FLYING HORSE NORTH FILING NO. 3
CONSTRUCTION DOCUMENTS

AS-BUILT VERSION 1.0, DATED 7/15/2026
PE: RICHARD LYON
CO PE NO. 53921

FLYING HORSE NORTH FILING 3
PRI #2, LLC.
EL PASO COUNTY, CO

SHEET
LG

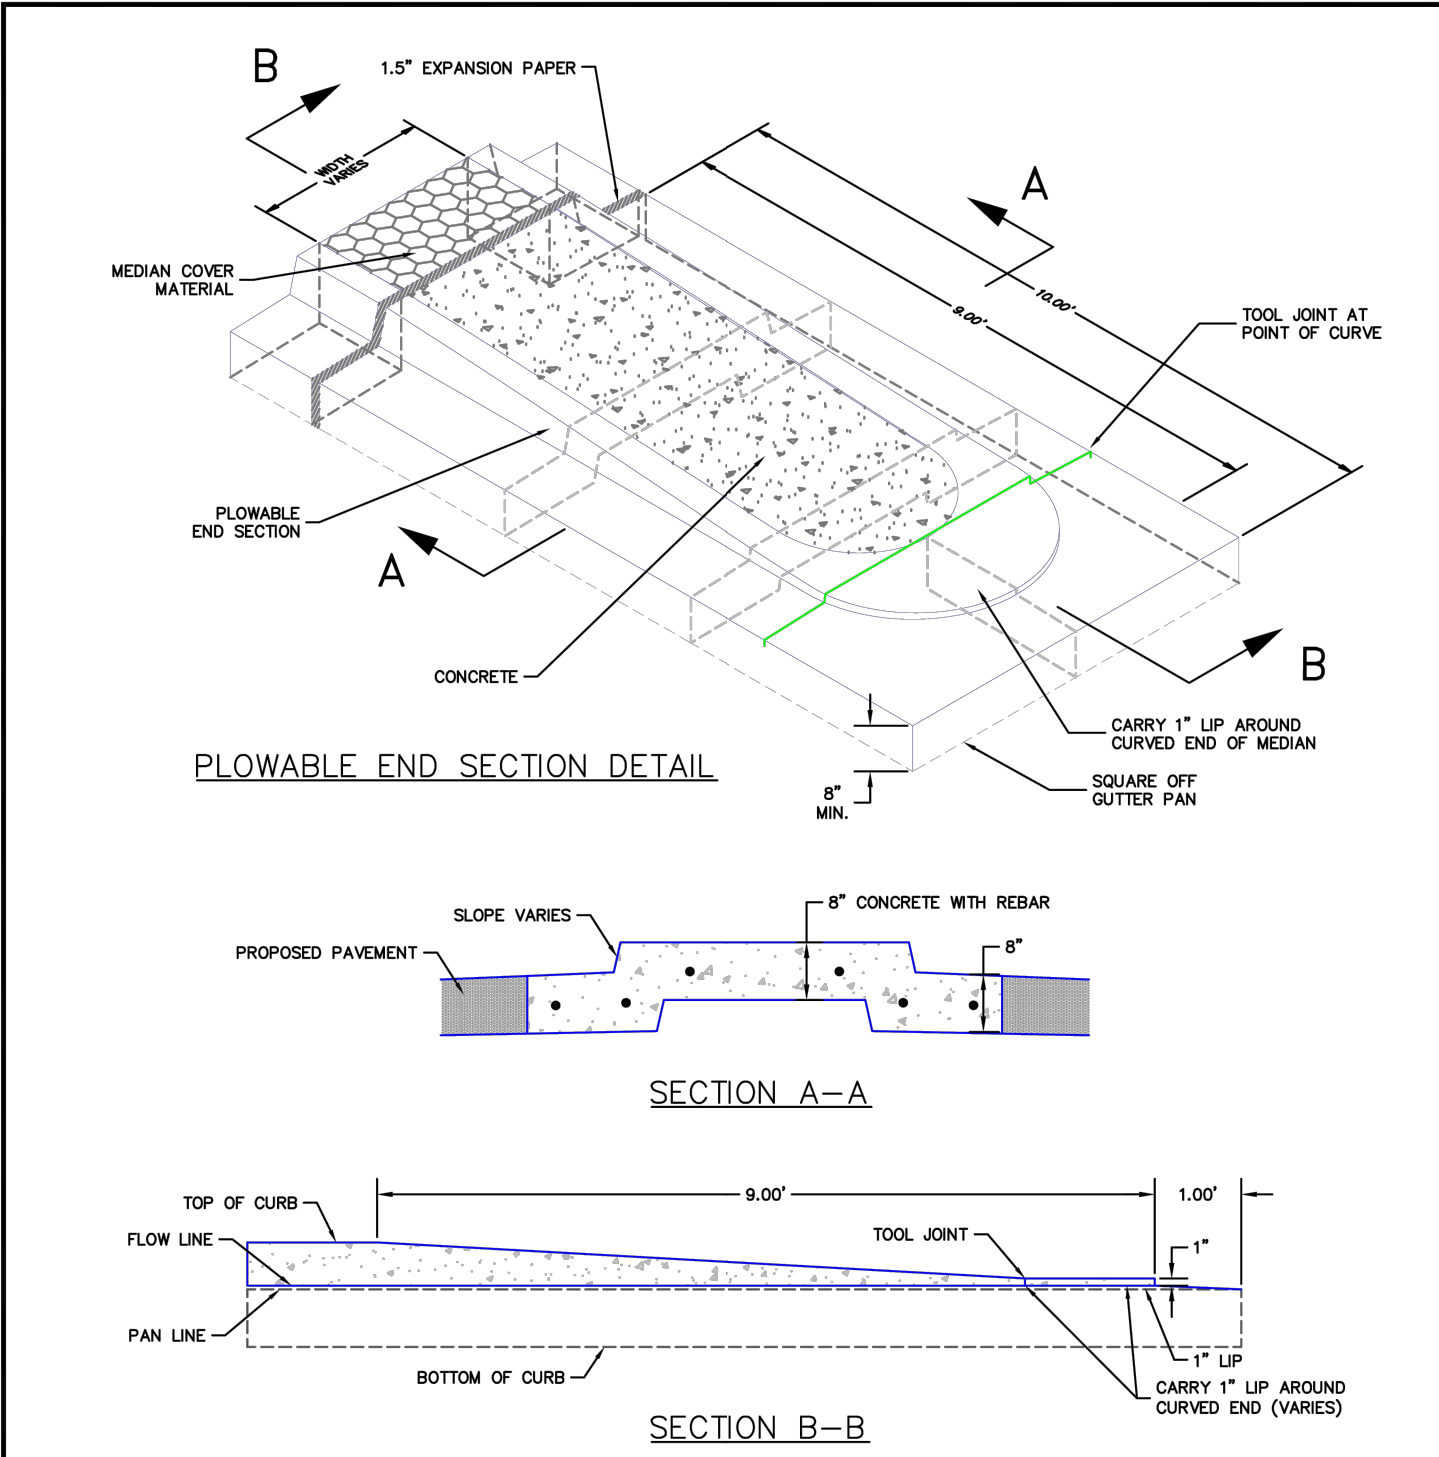
SHEET 2:
- CHANNEL CONSTRUCTION TO HAVE PERMANENT CHECK DAMS PER DISCUSSION WITH COUNTY STORMWATER ENGINEERING.

SHEET
STM

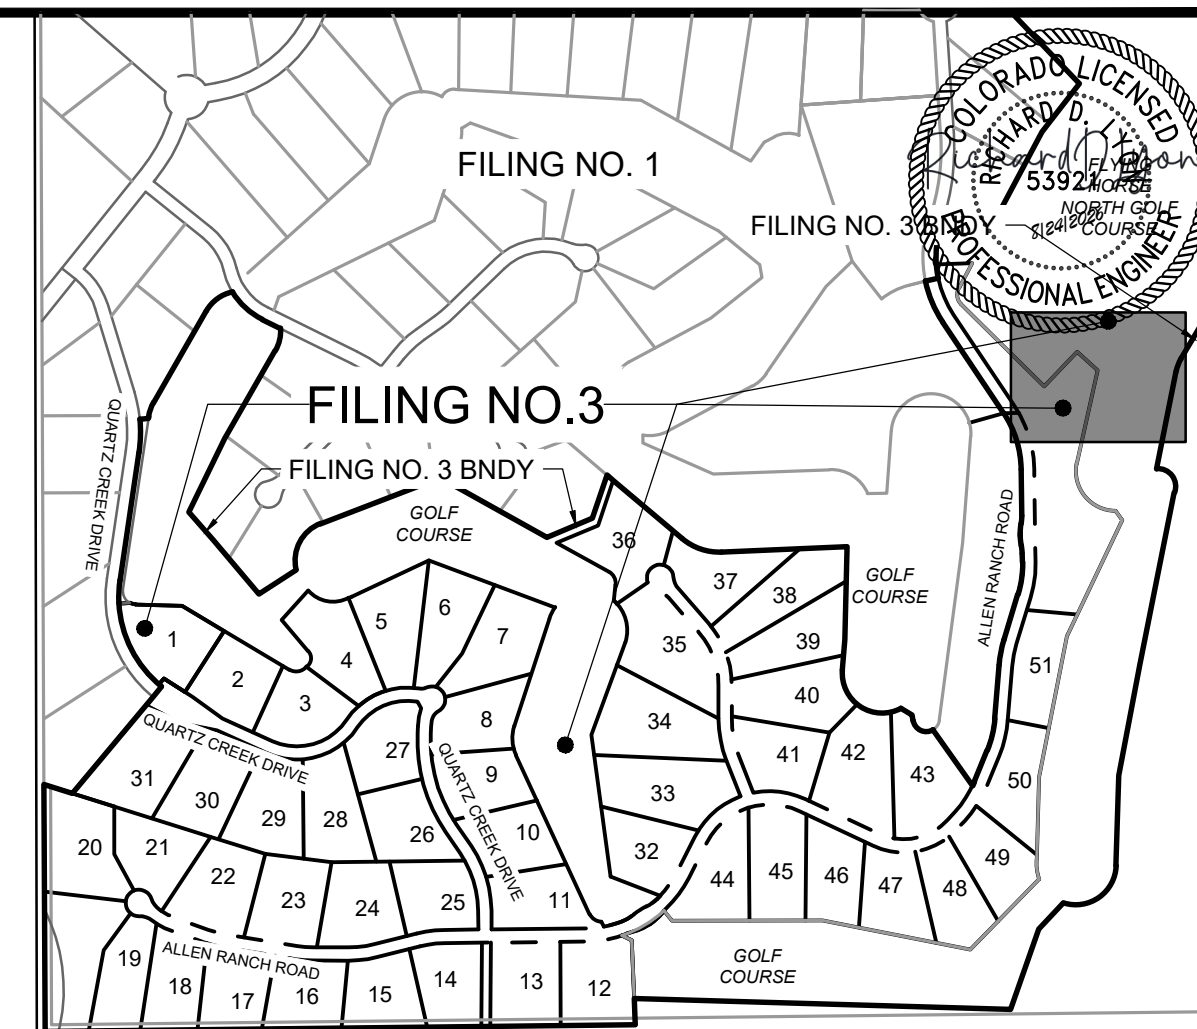
AS-BUILT: PAVEMENT SECTION IS CRUSHED CONCRETE.
SPECIFICATION OF CRUSHED CONCRETE ALLOWED BY EL PASO
COUNTY STORMWATER ENGINEERING.

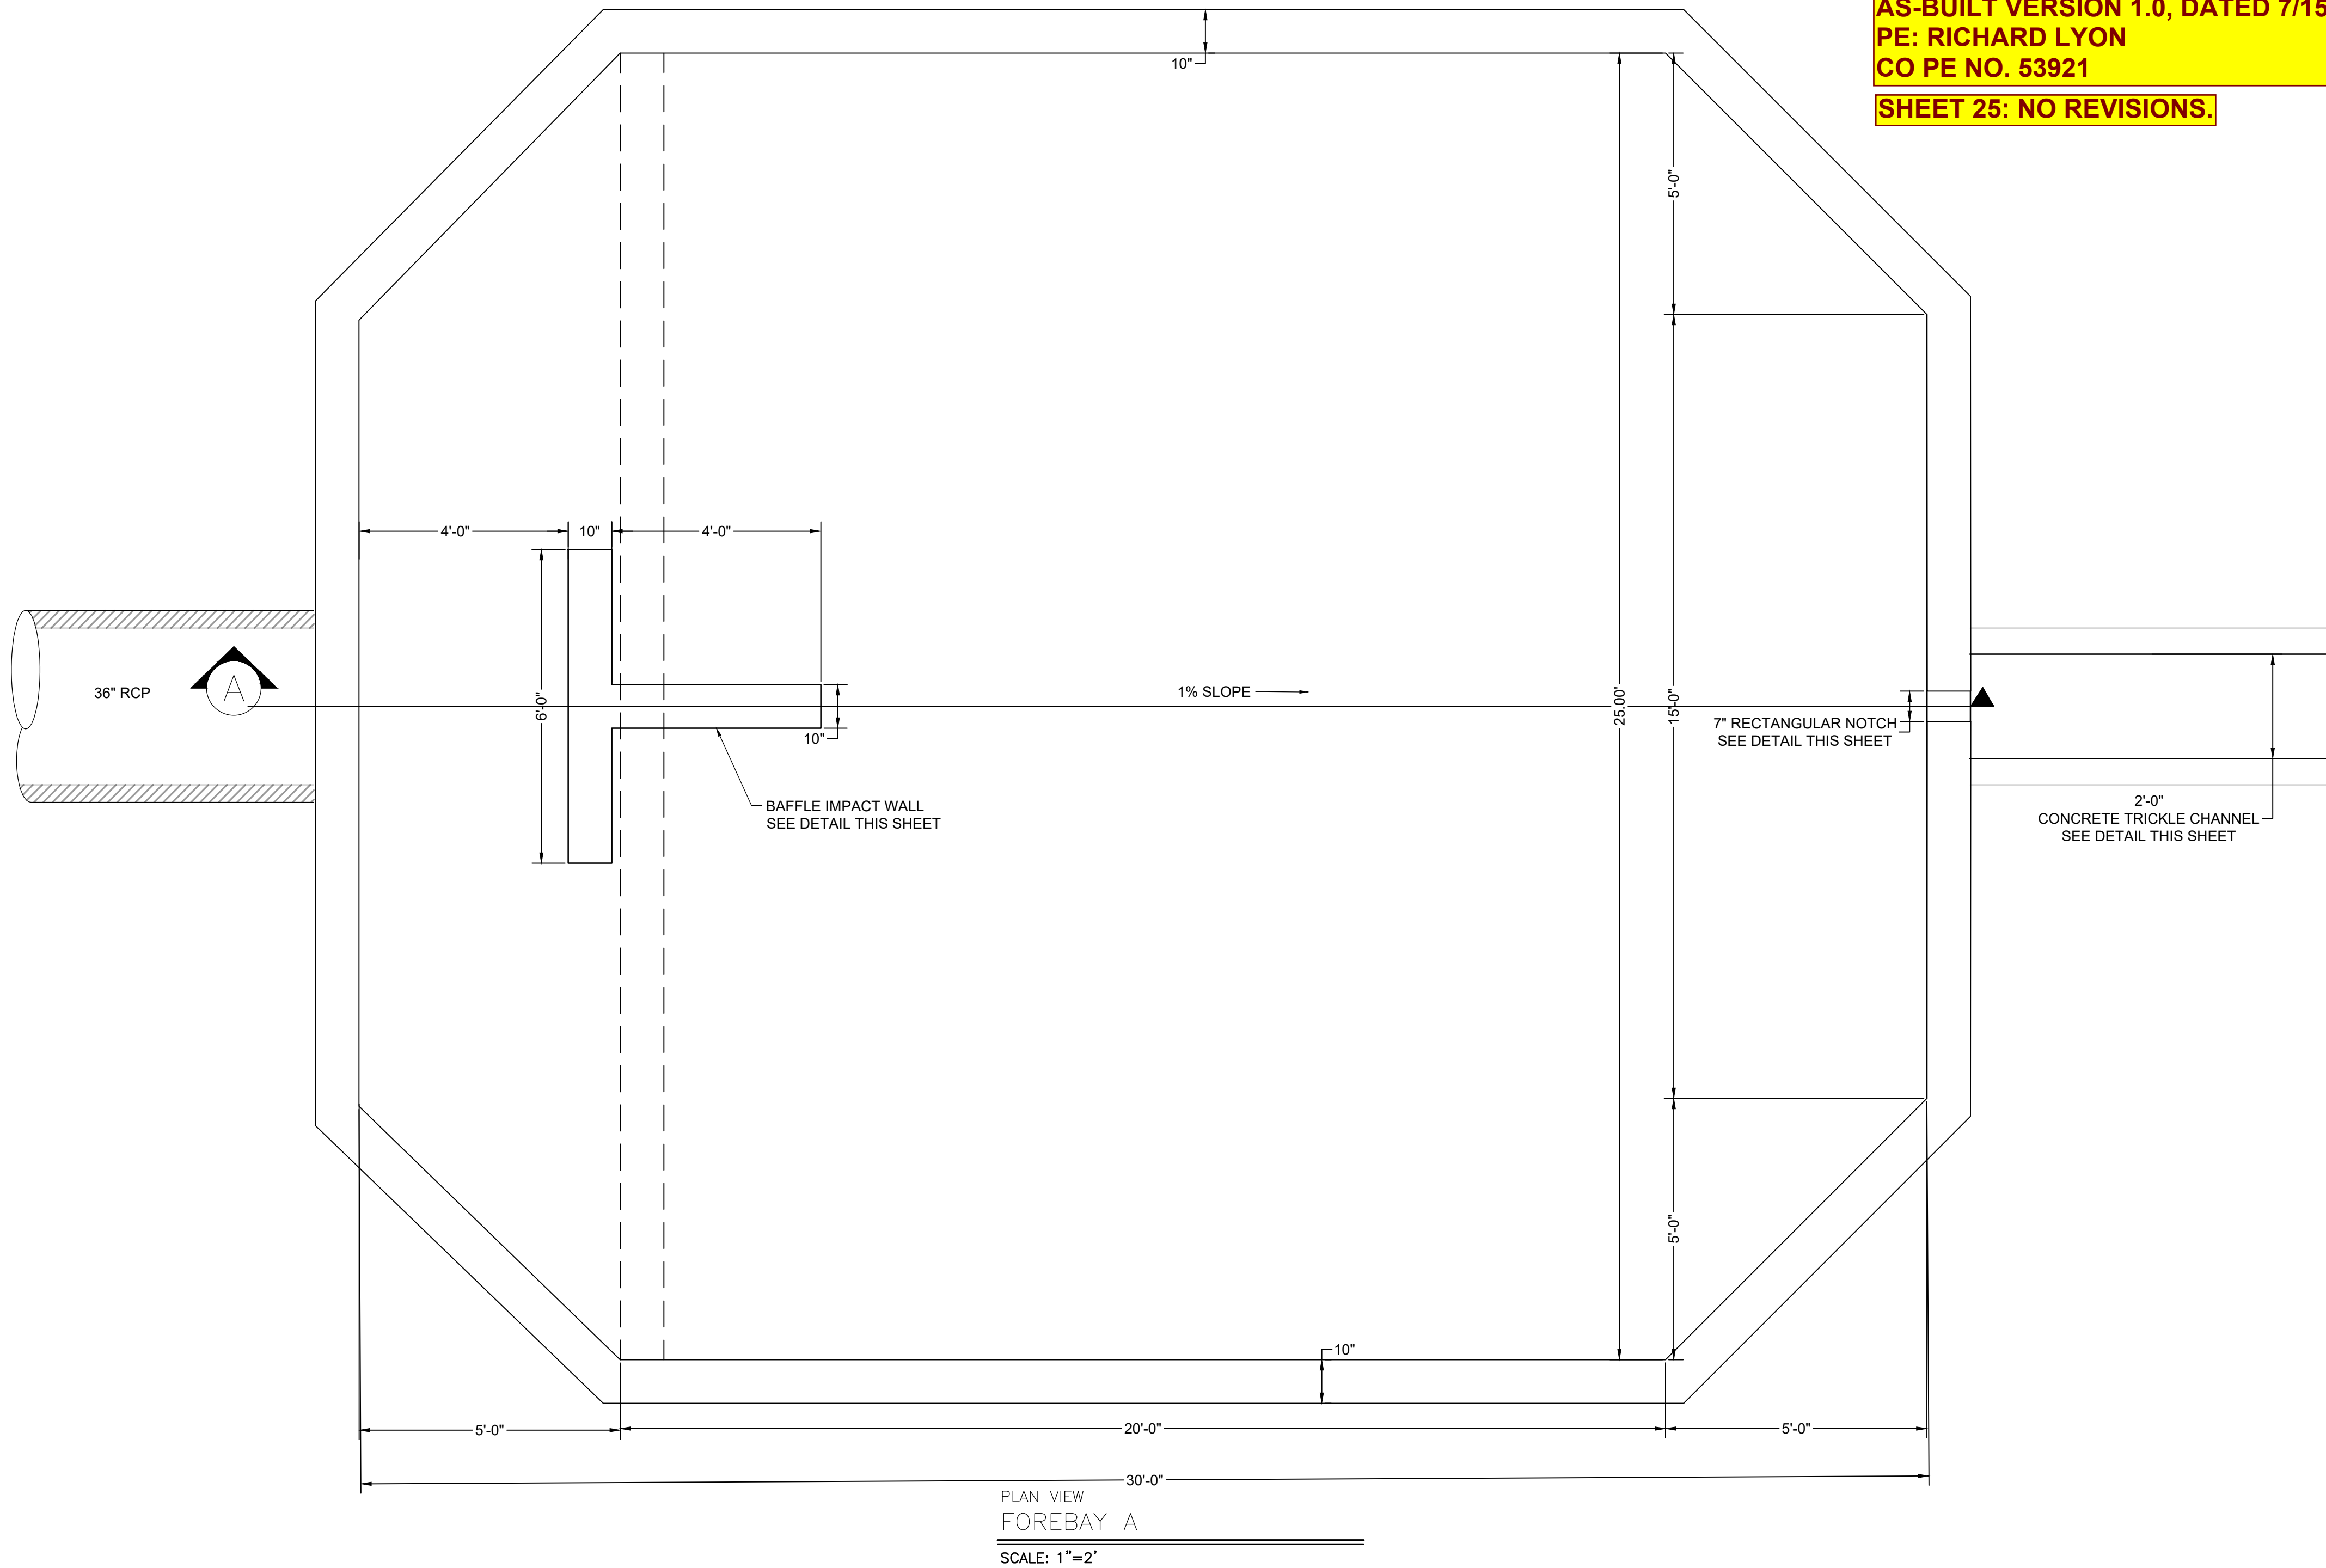
- CRUSHED CONCRETE FOR POND
- MAINTENANCE ACCESS
- EMERGENCY SPILLWAY
- ADJUSTMENTS PER DWR
- COMMENTS AND REQUESTS FOR
- FREEBOARD.
- EMERGENCY SPILLWAY
- EXPOSED RIP-RAP ALLOWED BY
- E.O.R.
- SEE DETAILS SHEET FOR
- MICROPOOL RETROFITS FOR
- ADDITION OF LADDER STEPS, BAR
- GRATE NOTES, ORIFICE PLATE
- REVISIONS, AND GASKET
- INSTALLATION.
- POND A HAS BEEN REGRADED
- TO MATCH RETROFIT
- REQUIREMENTS FOR FUTURE
- CLUBHOUSE DEVELOPMENT THAT
- DRAINS TO THIS FACILITY.
- (CDR259)
